**PATTERSON HIGH SCHOOL
&
CLAREMONT MIDDLE/HIGH SCHOOL**
Grades 6 through 12

UDARP Work Session
06 April 2017

#1

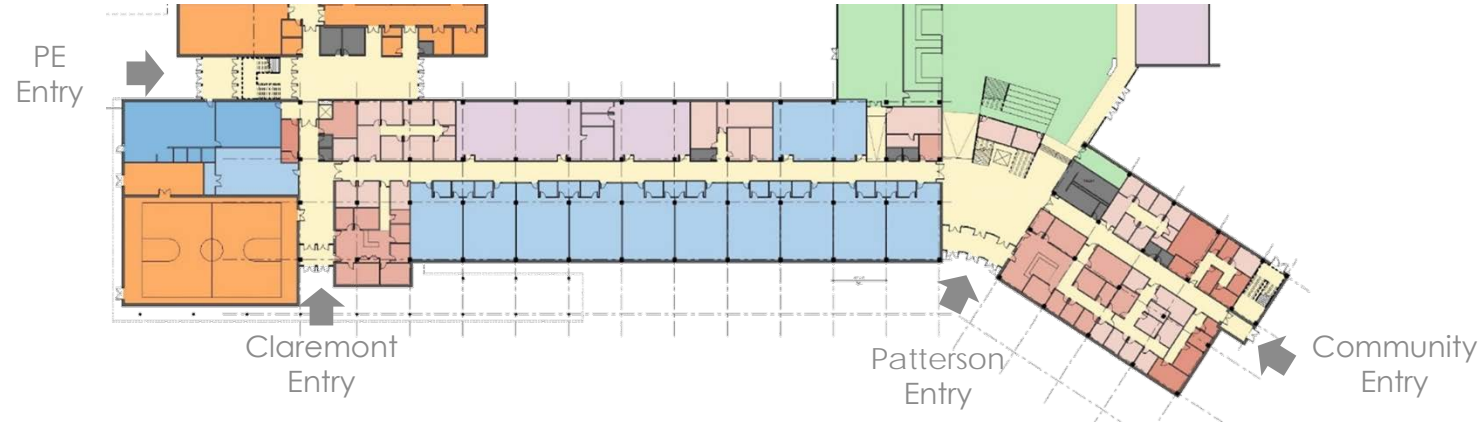
Consider Grouping Community Accessed Facilities into 1 Location/Entry Point

- Community currently has 2 entries (cafeteria/auditorium and PE Facility)

#2

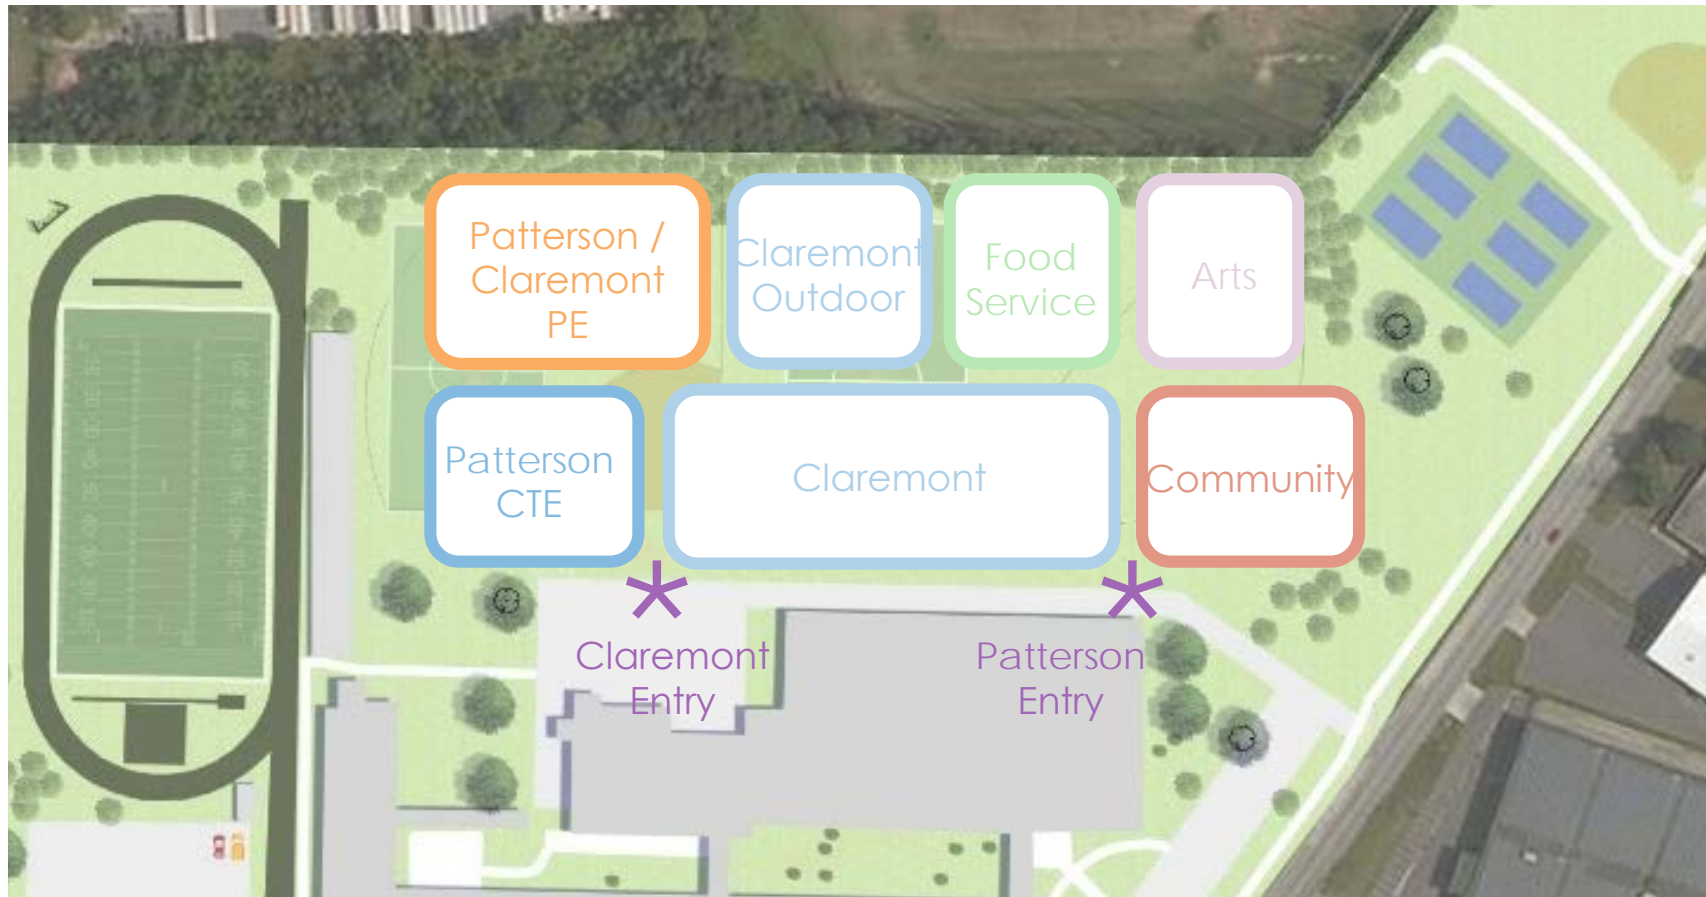
Consider Grouping all Ground Level Accessed Facilities for Patterson to 1 Location

- Auditorium/Cafeteria/Administration vs PE Facility seems problematic

- Claremont program must be on ground level
- Claremont program must be contiguous
- Claremont Outdoor must be directly accessible from Claremont
- Claremont and Patterson must share a kitchen but not dining
- Patterson community may not pass through Claremont space during the school day
- Claremont and Patterson must have separate entrances
- Community members must pass through Patterson Entry security

#3

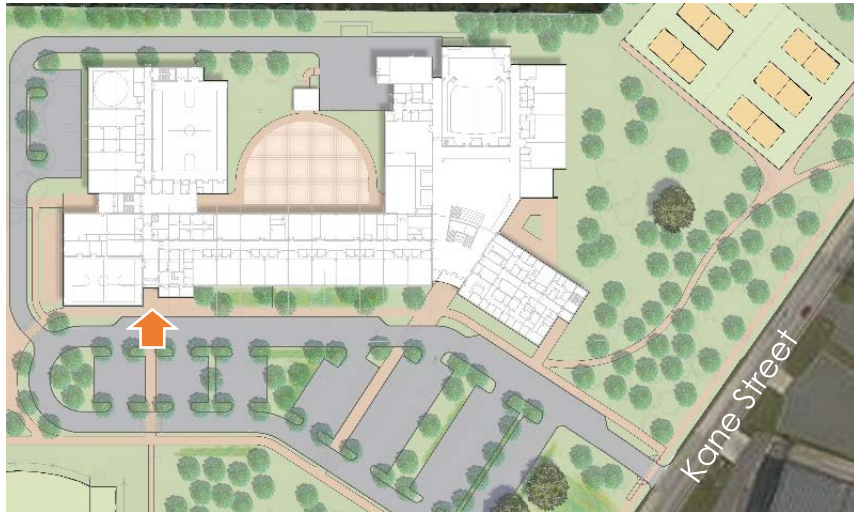
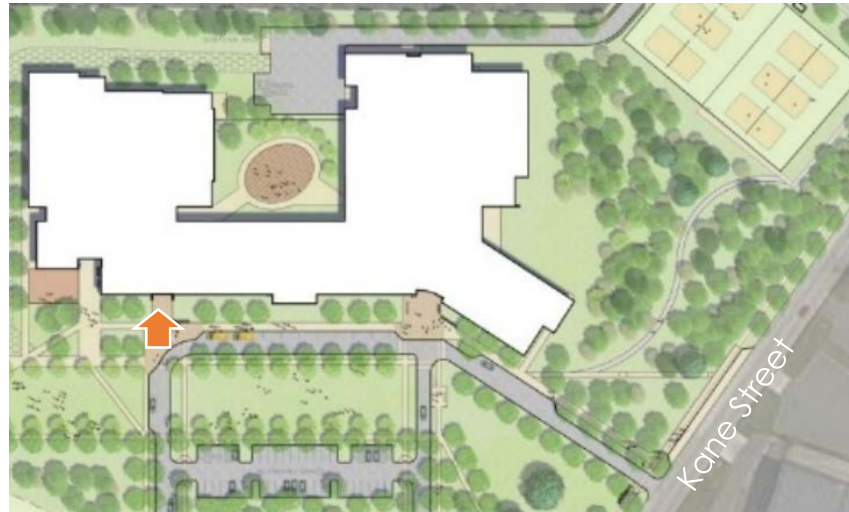
Reconsider Location and Visual Prominence of Claremont Entrance

- Feels lost behind a sea of parking
- Visually remote from Kane Street

- Claremont students require extensive assistance loading and unloading from busses
- Busses must have a place to stack while waiting to load/unload
- Busses may not stack in front of Patterson Entrance

#4

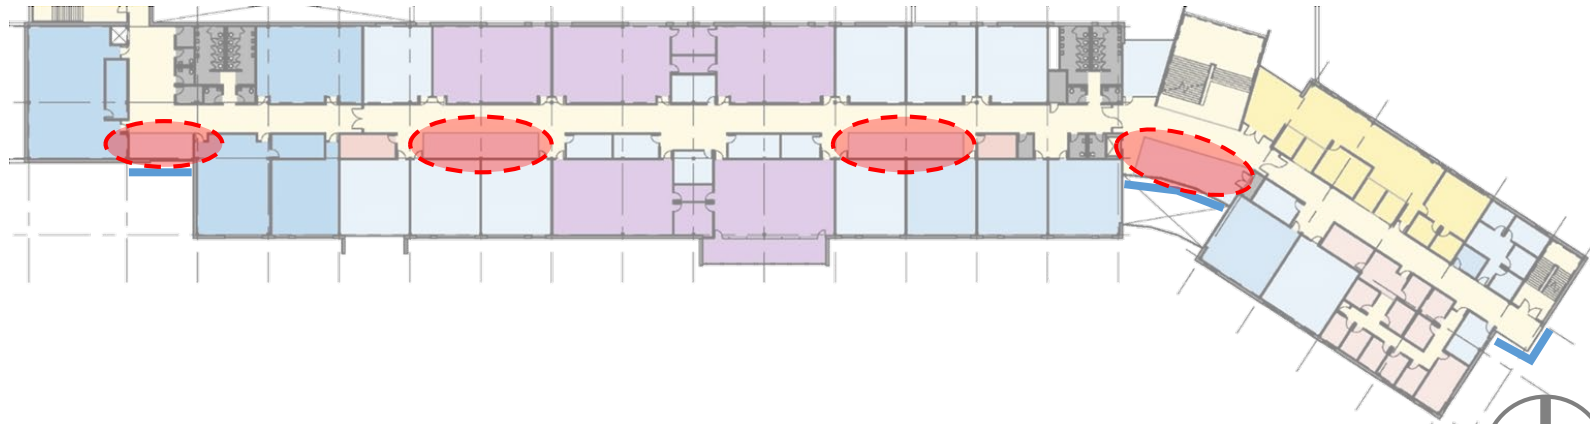
Reduce Negative Impact of Long Double Loaded Corridors

- Create Activity Nodes along the corridor
- View the space as both directional as a route and static as a place

Revised Site Plan

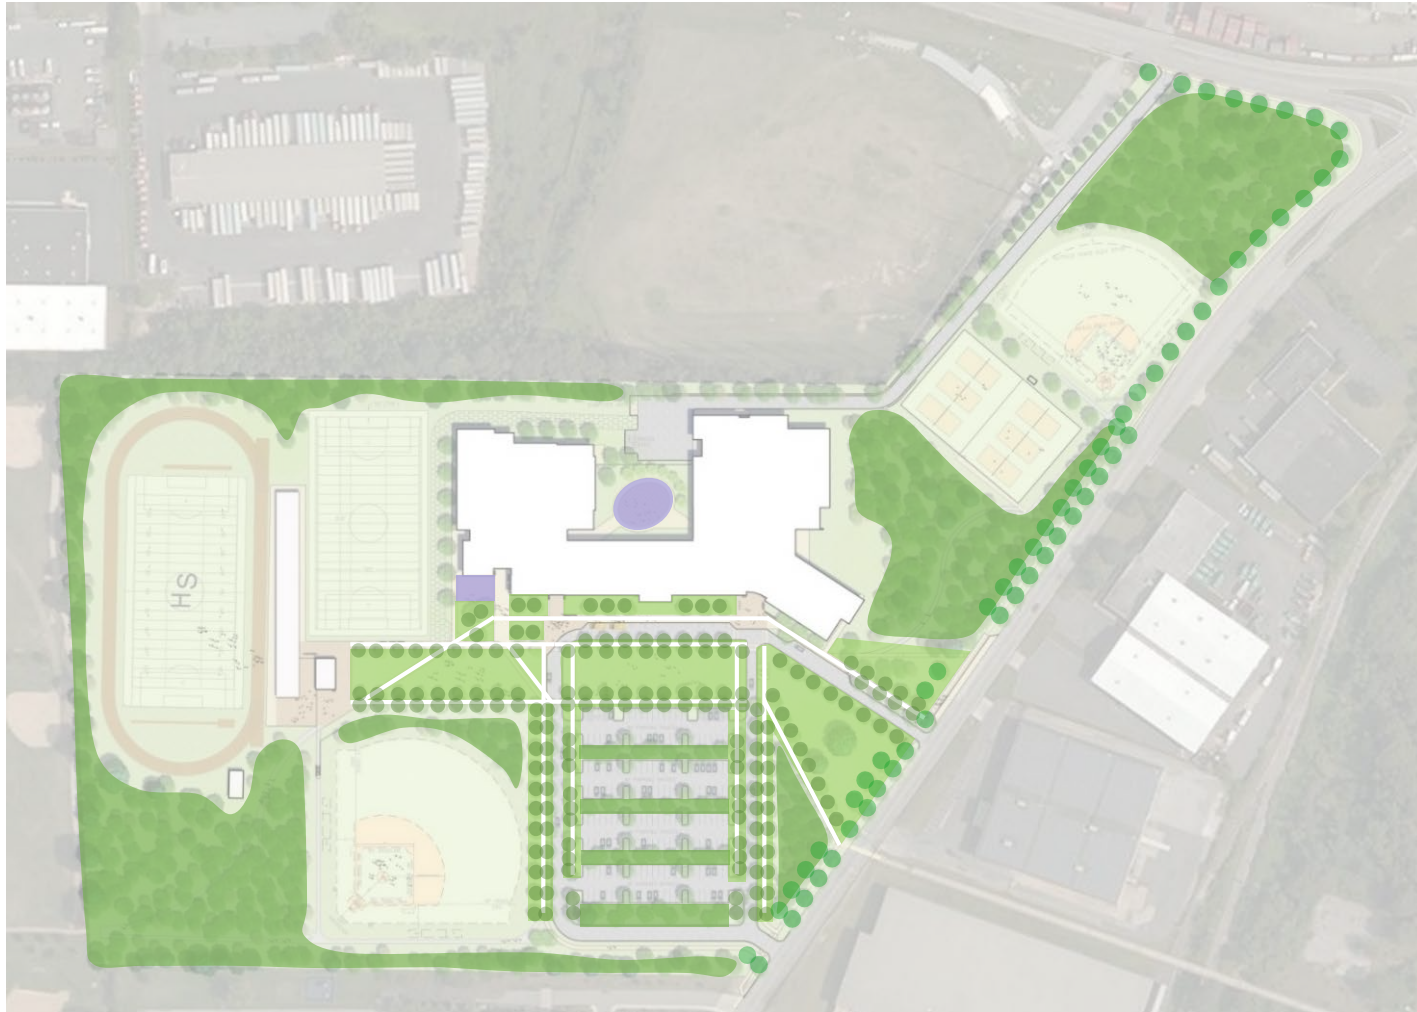
Make a Strong Urban Gesture

- Site now disconnected from neighborhood context
- Reorient building to Kane Street to embrace the community and the urban context

Site Pedestrian Circulation

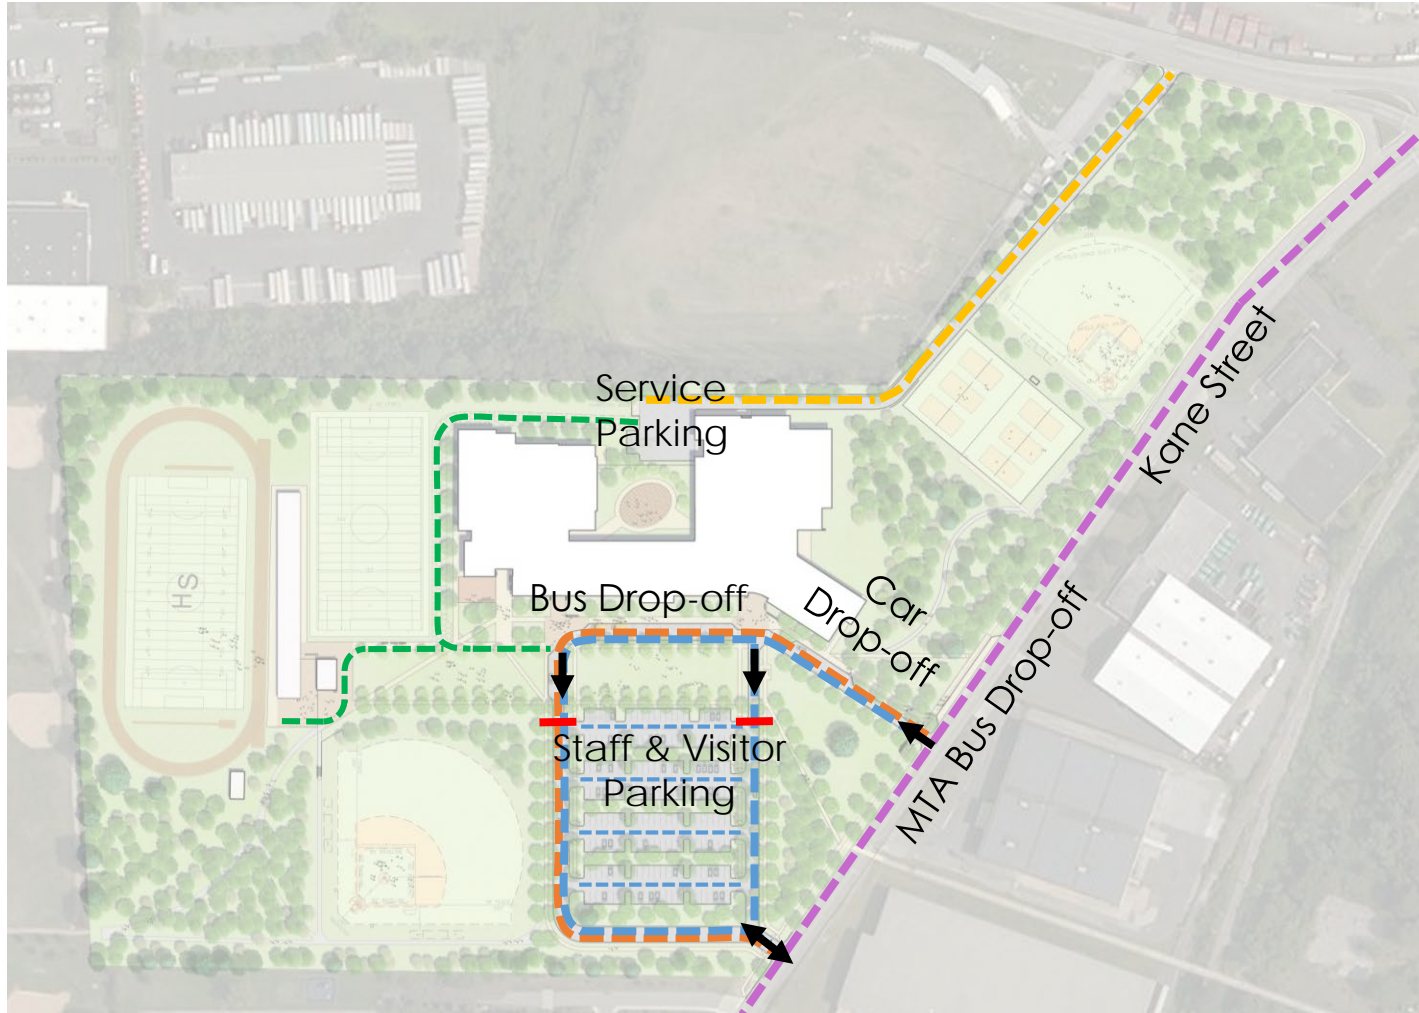
Improve Open Space Connectivity

- Strengthen connection of students in building to site open space and play fields
- Reduce parking and service access interference with this connection

#4

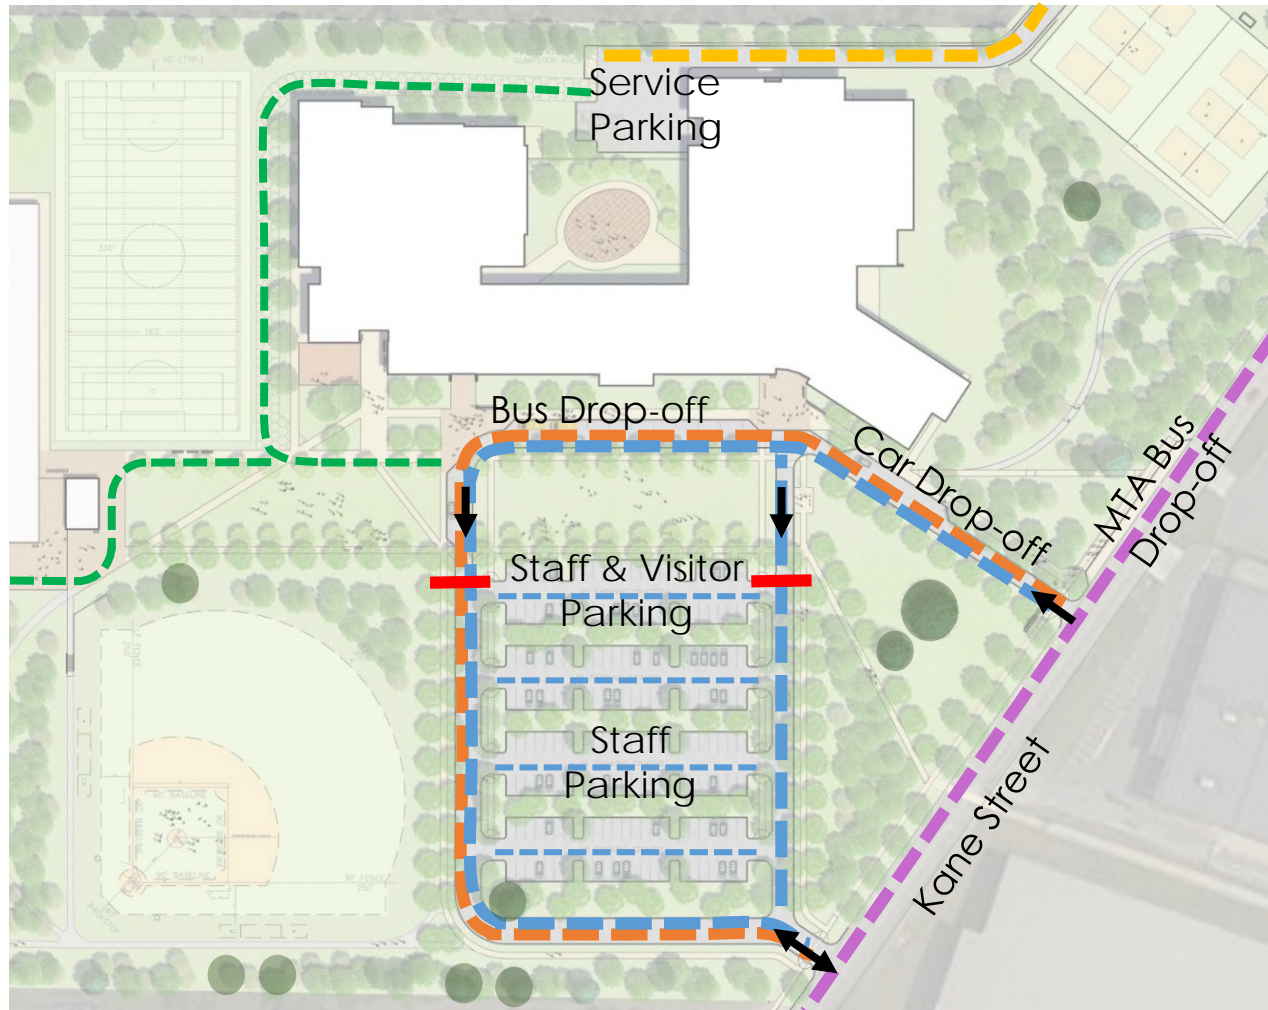
Improve On-Site Vehicular Circulation

- Clarify parking zones, student drop-off zones, and separate points of entry
- Minimize vehicular/pedestrian conflict

- School Buses
- Visitors & Staff Cars
- Service Vehicles
- MTA Buses
- Emergency Vehicles
- 2-Way Traffic Termination
